Subject: Byron Generating Station Units 1 and 2
Technical Specifications
NRC Docket Nos. 50-454 and 50-455

This is to provide comments and suggestions regarding the proof and review version of the Byron 1 Technical Specifications that was distributed in reference (b). NRC review of specific changes proposed here is necessary before the Technical Specifications can be finalized.

Attachments A through O to this letter contain marked-up pages of various sections of the Technical Specifications. A summary explanation of the changes is provided for each attachment. Justifications are provided where appropriate.

FIGURE 3.4-3

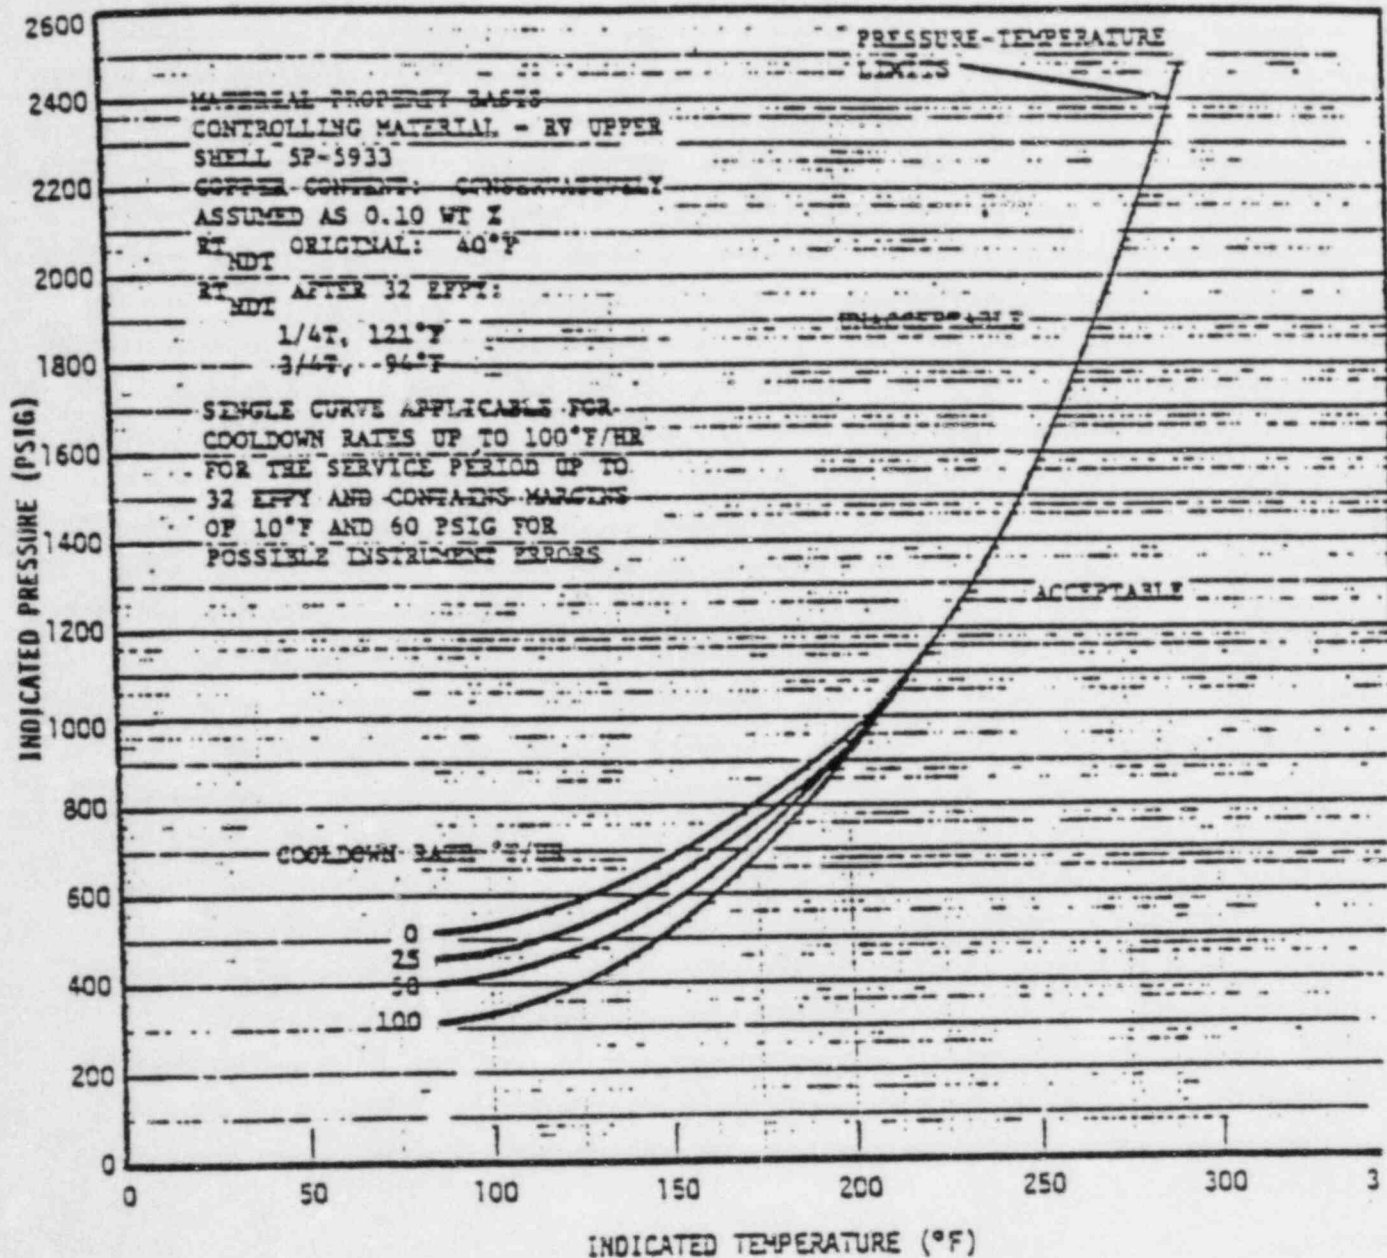
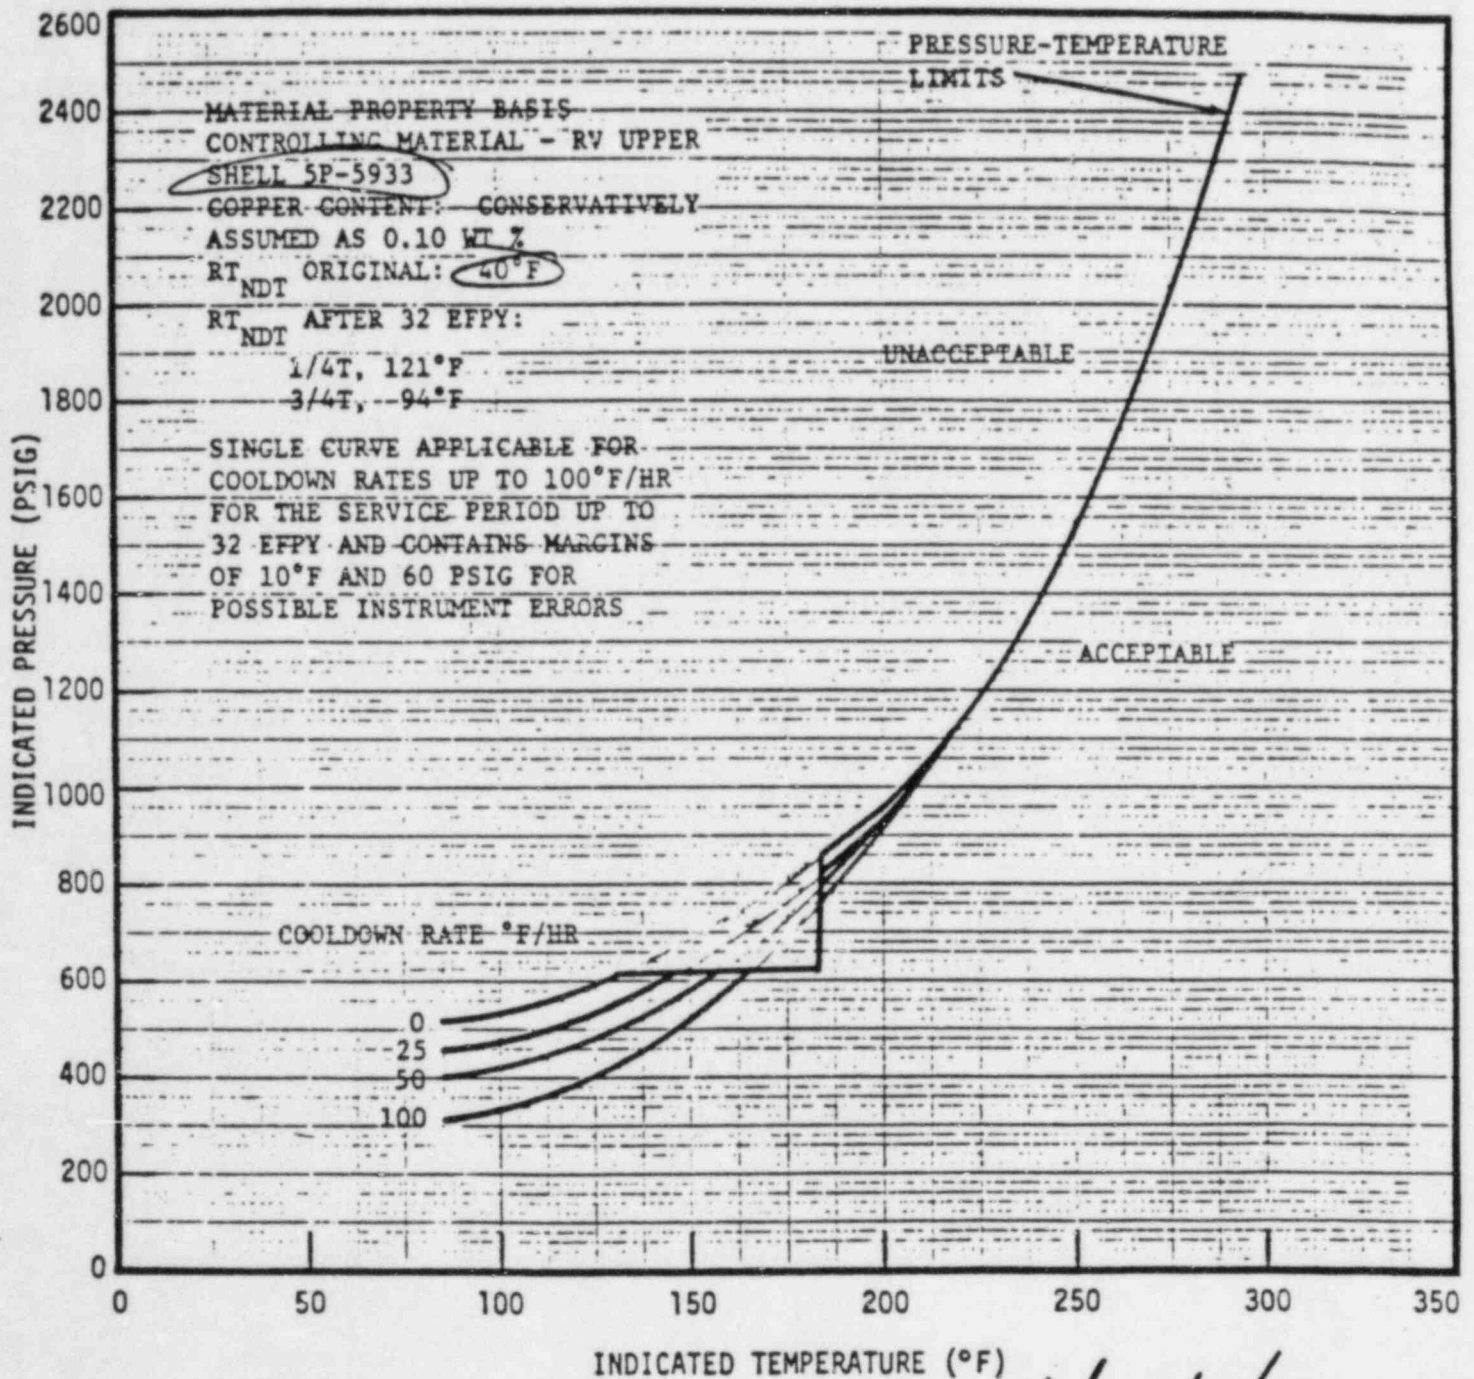
- 9) Figure 3.4-3 (Pg. 3/4 4-32) Reactor Coolant System Cooldown Limitations Applicable to 32 EFPY

Replace

This is to provide revised temperature limits for the Byron and Braidwood reactor vessels. These revisions were made necessitated by the May 27, 1983 amendment of Appendix G to 10CFR50.

The heatup and cooldown temperature limit curves for all of the Byron/Braidwood reactor vessels have been reviewed against the amended Appendix G requirements. Only the cooldown curves for Byron 1 and Braidwood 2 must be changed to incorporate the new closure flange limitations. Revised copies of those curves (FSAR figures 3.4-3a and 3.4-5b) are enclosed with this letter. Also enclosed is Table I, showing the data used in this review.
